Pub. 72 Change #4
 March 1977 Edition

SUBJECT: REVISIONS TO STANDARDS FOR ROADWAY CONSTRUCTION, RC-0-100
 CHANGE #4, TO MARCH 1977 EDITION.

REVISIONS TO STANDARDS FOR ROADWAY CONSTRUCTION, RC-0-100
CHANGE #3, TO MARCH 1977 EDITION

SUBJECT:
REVISIONS TO STANDARDS FOR ROADWAY CONSTRUCTION, RC-0-100
CHANGE #2, TO MARCH 1977 EDITION

Commonwealth of Pennsylvania DEPARTMENT OF TRANSPORTATION BUREAU OF DESIGN		
PAVEMENT JOINTS		
Recommended <u>Dec. 1, 1971</u> <i>RR Munn</i>	Approved <u>Dec. 1, 1971</u> <i>W.G. Rave</i>	Sht. 2 of 2
Location & Design Engineer	Deputy Chief Hwy. Engr.	RC-20

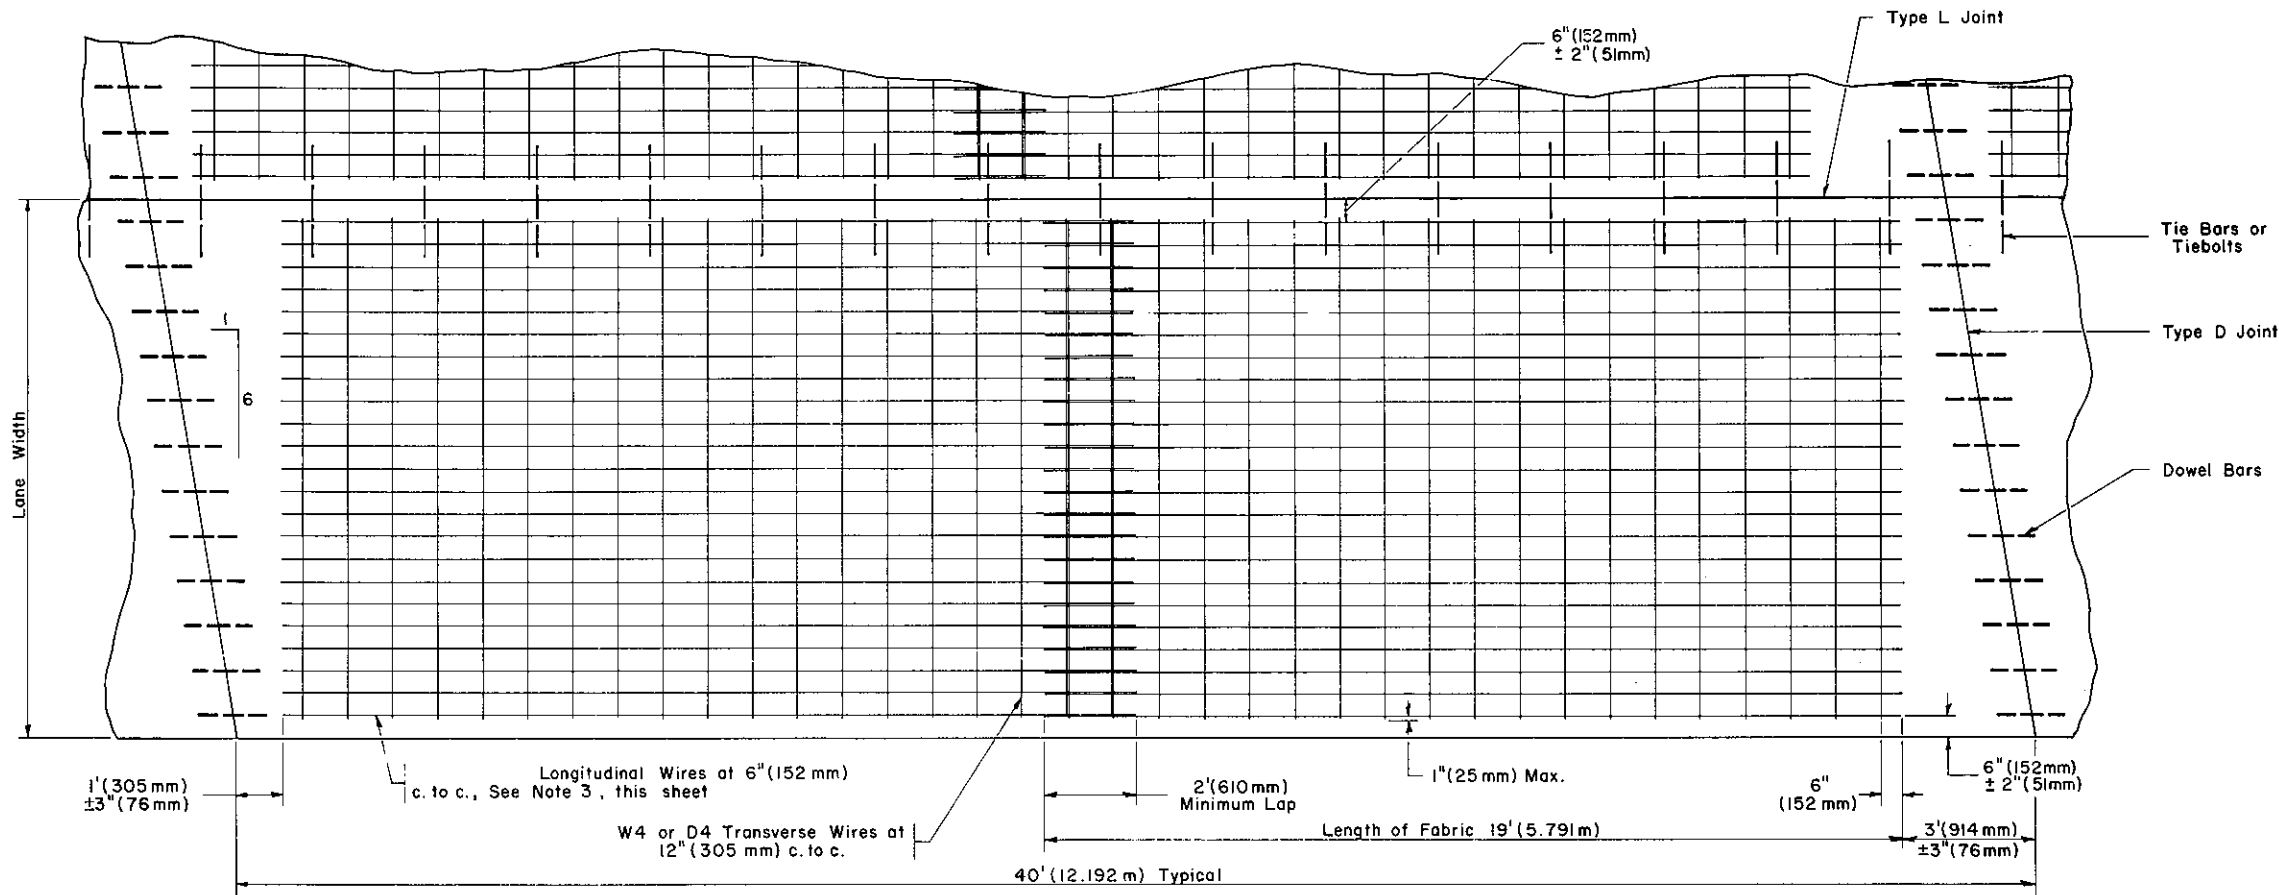
Sheet	Change Description
Index Sheet	- Revised to include the new sheets and dates.
RC-20, 1 of 2	- Redrawn to show new joint configuration.
2 of 2	- Redrawn to show new joint configuration.
RC-21, 1 of 1	- Redrawn to show new joint spacing and reinforcement.
RC-22, 1 of 4	- Redrawn to reflect the addition of 6" and 7" overlay.
2 of 4	- Joint type added.
3 of 4	- Joint type added and note change (Notes 1, 2, 3, & 4)
4 of 5	- This sheet was eliminated.
4 of 4	- Changed Table 3 (Added 6" & 7")
RC-23, 1 of 2	- Changed the notes and eliminated the 10' section of RCC Pavement and the reference to the Pavement Relief Joint.
2 of 2	- Removed the notes referring to outdated ST drawings.
RC-24, 1 of 1	- The Pavement Relief Joint has been redesigned and designated to be used only on reconstruction projects.
RC-25, 1 of 3	- Redrawn to show only Types 1 & 3 Shoulders. Added note for shoulder rounding and made minor changes to the notes.

Recommended <i>May 31, 1979</i> <i>B.D. Rasmussen</i> Director, Bureau of Design	Approved <i>May 31, 1979</i> <i>David A. Smith</i> Chief Hwy. Engr.	Sht. 1 of 4 RC-22
--	---	-----------------------------

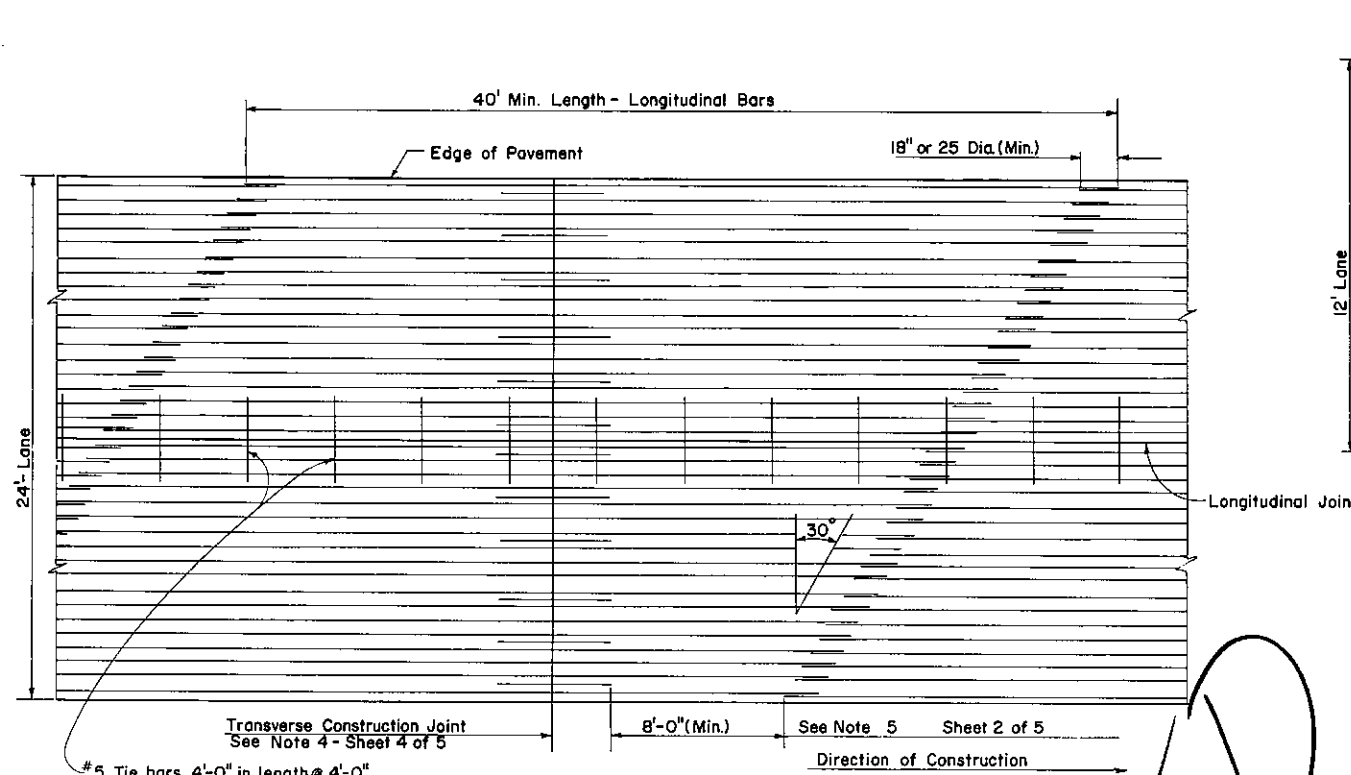
2 of 3	- Changed Notes 1 & 6 to clarify the pay items.
3 of 3	- New sheet for Concrete Shoulders.
RC-26, 1 of 3	- Pen and ink change. Change the date on the drawing to May 31, 1979.
2 of 3	- Changed Detail A to joint detail. Also changed the notes and tiebolts and underdrain.
3 of 3	- New sheet for joint repair.
RC-27, 1 of 2	- New sheet for Plain Cement Concrete Pavement.
2 of 2	- New sheet for Plain Cement Concrete Ramps.
RC-31, 1 of 1	- Added Diminsion for 4" Subsurface Drain Outlet Endwall.
RC-34, 1 of 6, 2 of 6, 3 of 6, 4 of 6, & 6 of 6	- Pen and ink change. Change the dates on these drawings to May 31, 1979.
5 of 6	- Added Note 10.
RC-41, 1 of 1	- Pen and ink change. Change the 3" dimension on Section D-D to 6".
RC-43, 1 of 1	- Pen and ink change. Change the 6" dimension for Mattress Type Gabions to 9".
RC-57, 1 of 2	- Added the detail for the plate slot.
2 of 2	- Pen and ink change. Change the date on the drawing to May 31, 1979.

Recommended <i>May 31, 1979</i>	Approved <i>May 31, 1979</i>	Sht. 1 of 2
<i>B.D. Kunkin</i> Director, Bureau of Design	<i>David Adams</i> Chief Hwy. Engr.	RC-57

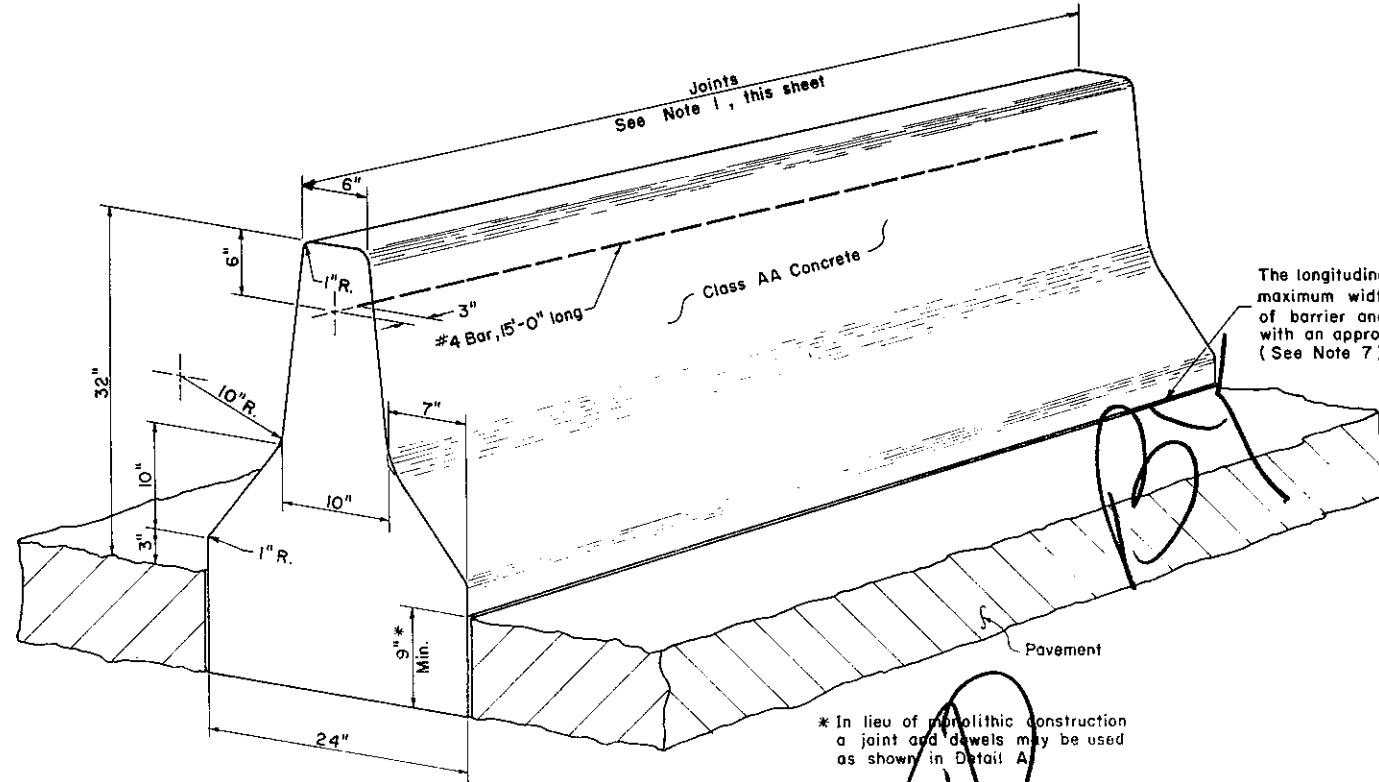
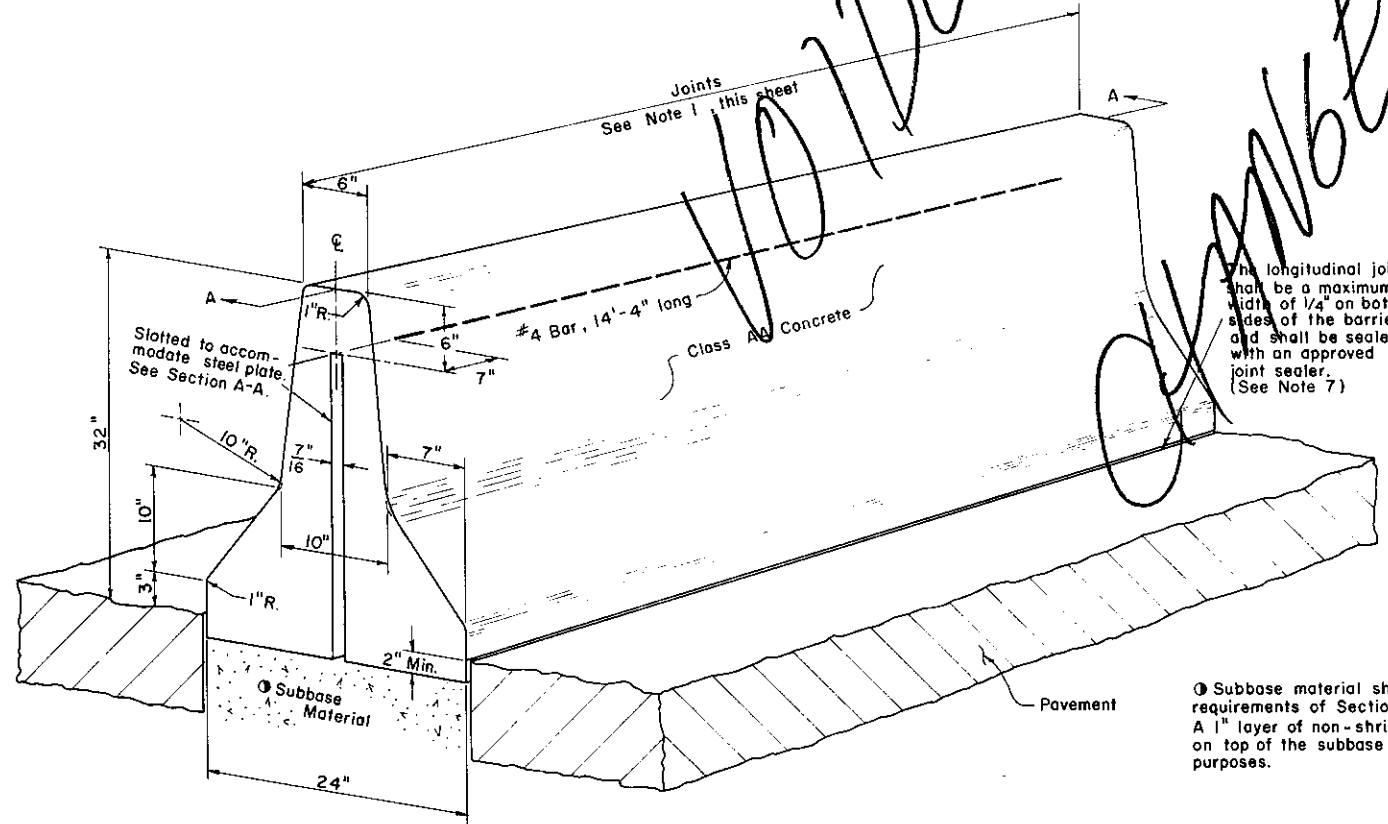
Sheet	Change Description
RC-54 (2 of 3)	- Changed the 5'9" Typical placement of guard rail to 4'9".
(3 of 3)	- The end treatment for Median Treatment at Dual Structures was changed to the Breakaway Cable Terminal End Treatment.
RC-55 (1 of 1)	- Revised sheet references to comply with RC-52 drawing change.
RC-56 (1 of 1)	- Added a note to allow the internal splice plate to be threaded as an alternate to tack welding hex nuts.
RC-83 (1 of 2)	- Revised guard rail clearances at lighting poles to comply with minimum design clearances for different types of weak and strong post guard rail. Design Manual Chapter 7 - Lighting - will be changed to comply with this criteria in a future change.
(2 of 2)	- Added a new sheet to RC-83 for standard high mast lighting poles.

Recommended <i>Sept. 1, 1978</i> <i>B. D. Connelley</i> Director, Bureau of Design	Approved <i>Sept. 1, 1978</i> <i>James M. Schubert</i> Deputy Chief Hwy. Engr.	Sht. 2 of 2 RC-60
--	--	-----------------------------

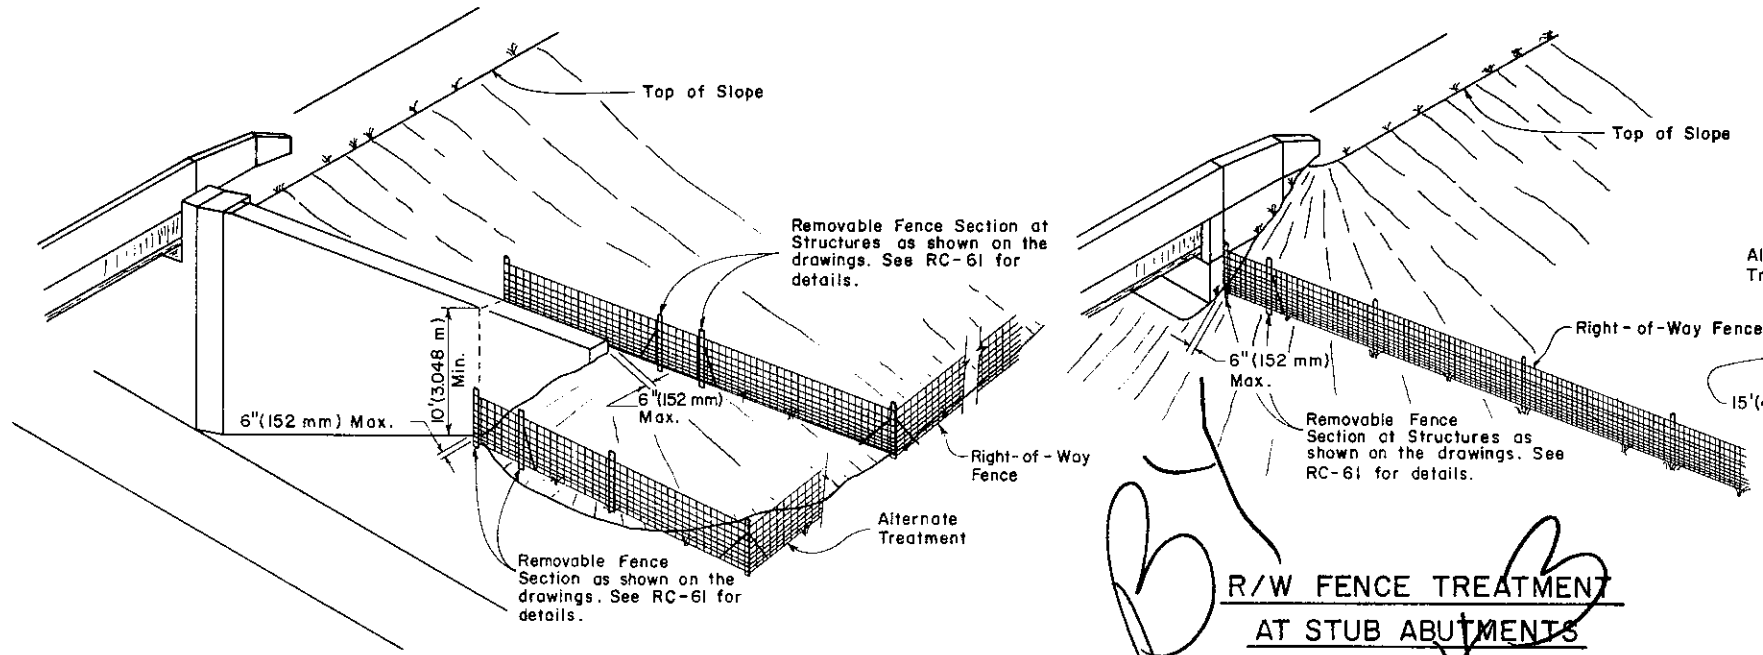
Added details showing Right-of-Way Fence positioning at structures. Added the use of Drive Anchors as alternates for concrete footings. Note that the positioning of the Right-of-Way Fence is 2 feet inside of the Right-of-Way Line.

Added a detail for Removable Fence Sections at Structures. These are to be used as required to permit access for bridge inspection or other necessary entrance.
